## Department of Transportation

#### MEMORANDUM

**SUBJECT:** ZC Case No. 66-68A – Edgewood Terrace

**Figure 1 | Site Plan** (Source: Wiencek + Associates, Exhibit 25A1 10/28/2020)

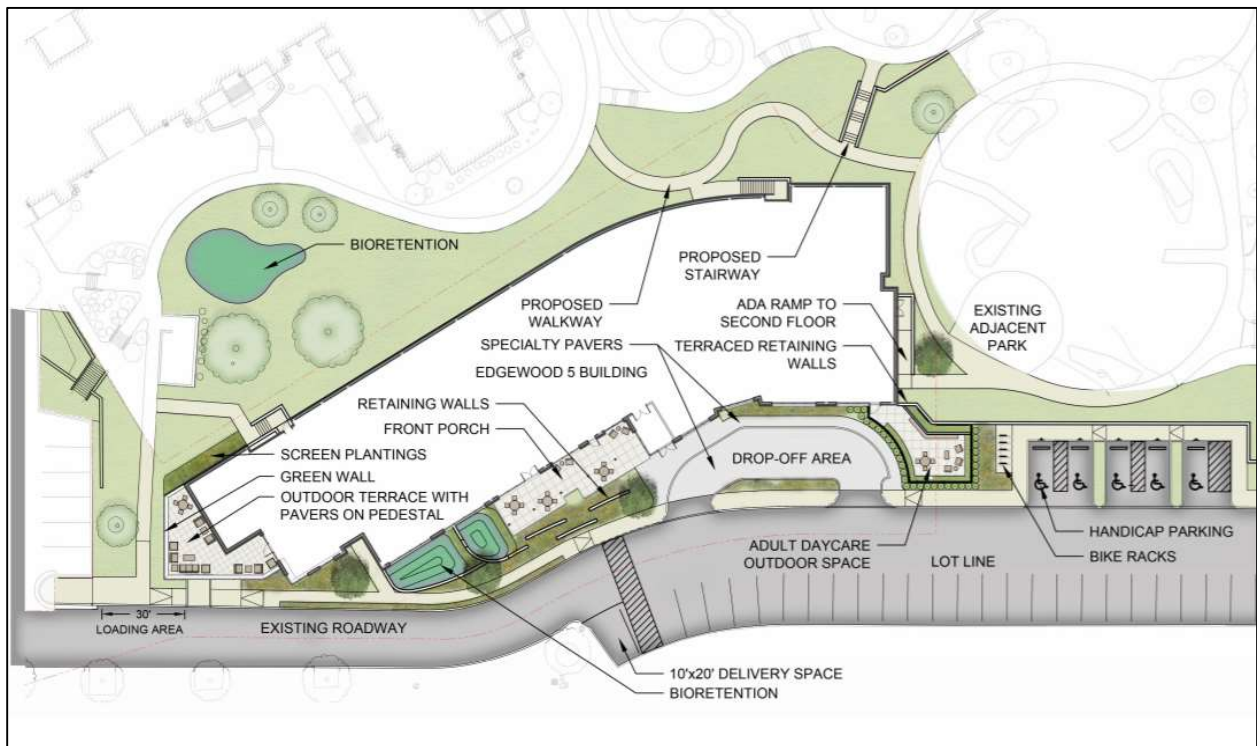
Vehicular access to the site includes a drop-off area on the southern side of the building. The Applicant proposes five (5) new ADA-accessible handicap parking spaces to the east of the building. The project proposes no new curb cuts to the public street network but does include three new curb cuts on the private drive for access to the drop-off area and trash room. The private driveway connects to 4<sup>th</sup> Street to the west of the project. That entrance will be reconfigured by the Bryant Street redevelopment project south of the site (LTR 2017-02) and the consolidated driveway realigned opposite Channing Street NE. Figure 1 below shows the site layout of the proposed project.

The Applicant proposes to provide curbside trash pick-up along the 20-foot internal driveway and 30-foot loading zone area, at the request of DDOT and OP, in order to maintain the outdoor terrace above which would be eliminated if internal loading facilities are provided. Trash will be stored inside the building and bins rolled to the curb on private property. Move-in and move-out activities and deliveries will occur either in a vehicle parking space or within the pick-up/drop-off loop at the front entrance.

DDOT concurs with the proposed LMP above and has no objection to the site's loading scheme and requested areas of relief so long as the LMP is included in the final Zoning Order.

Figure 4 | Existing Pedestrian Network (Source: Gorove Slade 9/24/2020 Transportation Statement, Figure 6)

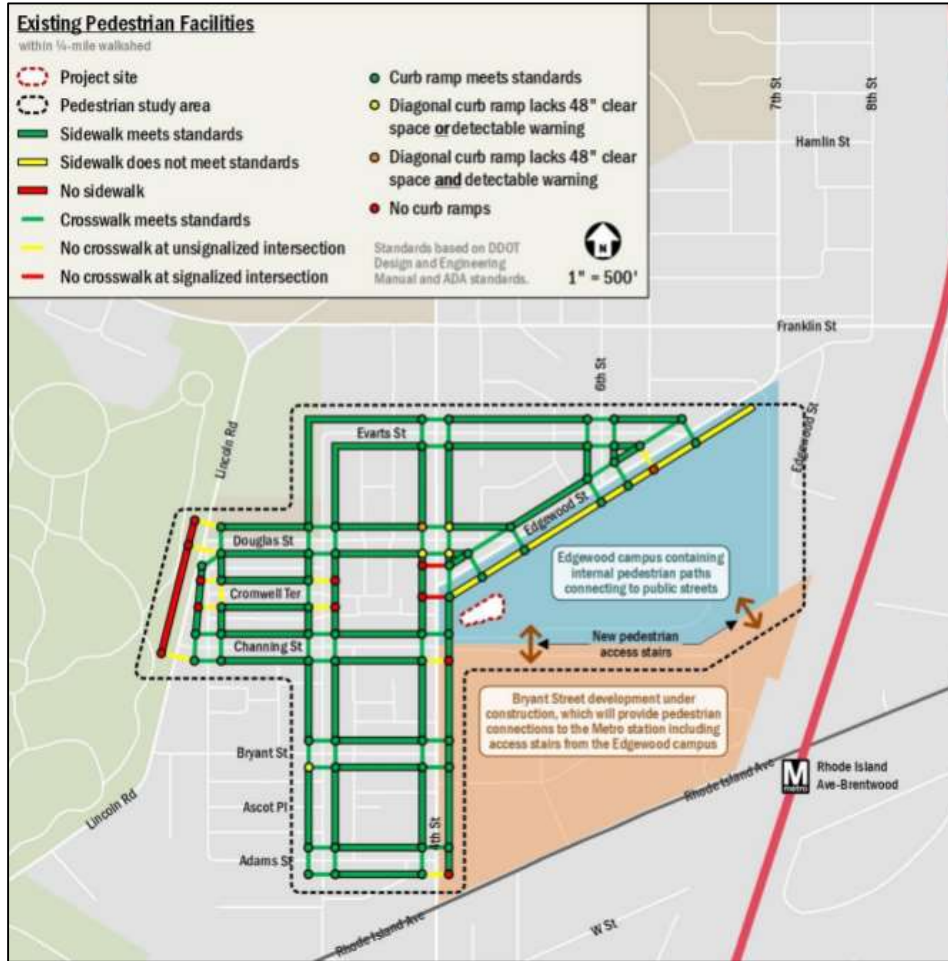
The Applicant’s inventory of existing pedestrian infrastructure, as shown in Figure 4 below, demonstrates that most sidewalks in the immediate vicinity of the site are currently constructed with appropriate widths and include accessible curb ramps, except for Edgewood Street. While there are a number of missing or substandard facilities in the broader area, the existing pedestrian network along major walking routes from the site to schools, attractions, and the Metrorail station is generally adequate, especially given the pedestrian improvements that will be constructed as part of the Bryant Street redevelopment project south of the subject site.

To address some pedestrian safety issues, the Applicant proposes to provide pedestrian striping along several portions of the private drive south of the proposed development (see Exhibit 23A1). The Applicant will also construct one crosswalk that connects the proposed development to the stairs that will be constructed as part of the Bryant Street NE project south of the site (LTR 2017-02). This will provide greater connectivity to the Rhode Island Avenue-Brentwood Metro Station. DDOT requests the Applicant also construct curb ramps at both ends of the crosswalk, if not completed by others, to ensure as many people as possible, of all ages and abilities, can access the future staircase.
